SUBMISSION ON HOXTON PARK ROAD UPGRADE BY LIVERPOOL CITY COUNCIL (October 2019)

This is a submission by Liverpool City Council on the Community Update released by the NSW Government in relation to the Hoxton Park Road Upgrade on 2 October 2019. The submission sets out Council's recommendations in relation to this project.

Figure 1 - Planned rapid transit corridor (courtesy of RMS)

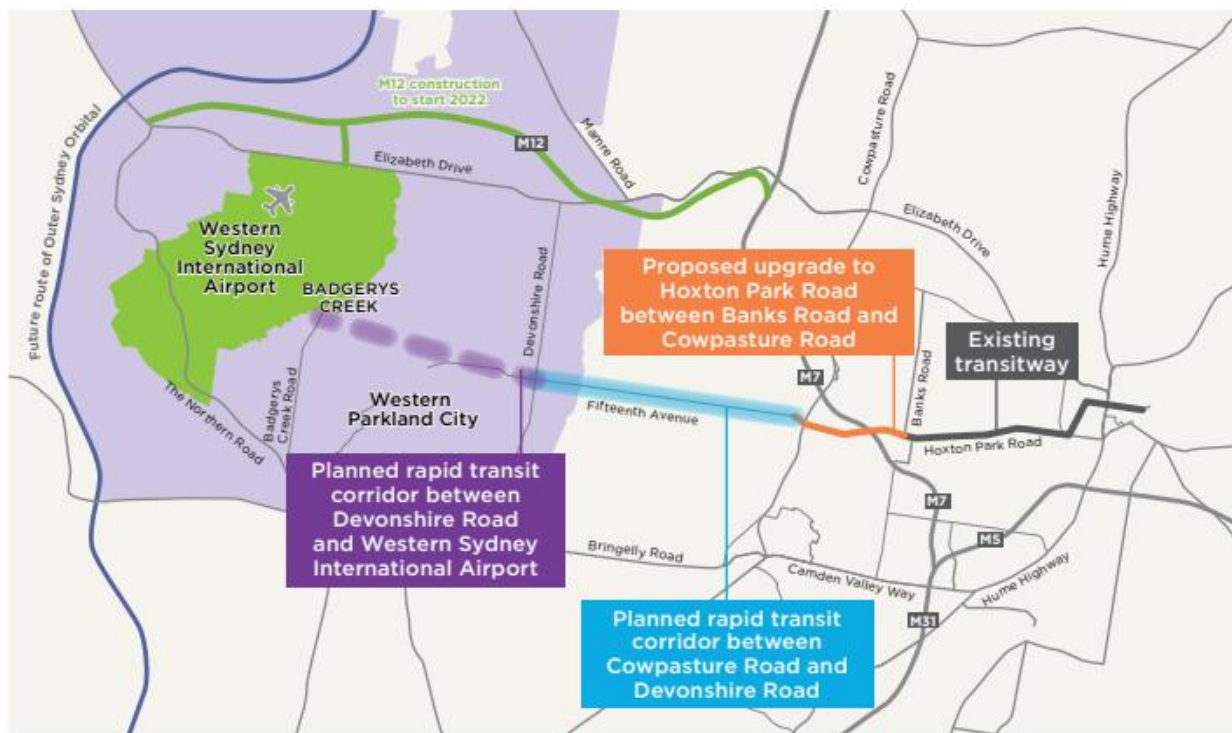
The commitment to upgrading Hoxton Park Road forms an important 'missing link' in providing a connection between the new airport and Liverpool's CBD. The upgrade is also consistent with Liverpool City Council's ongoing work to deliver rapid transit along Fifteenth Avenue (the Fifteenth Avenue Smart Transit [FAST] Corridor project) and work that Transport for NSW has under way to plan a rapid transit connection from Fifteenth Avenue to the airport.

Figure 1 from the Community Update represents current work by each level of government to deliver this crucial link:
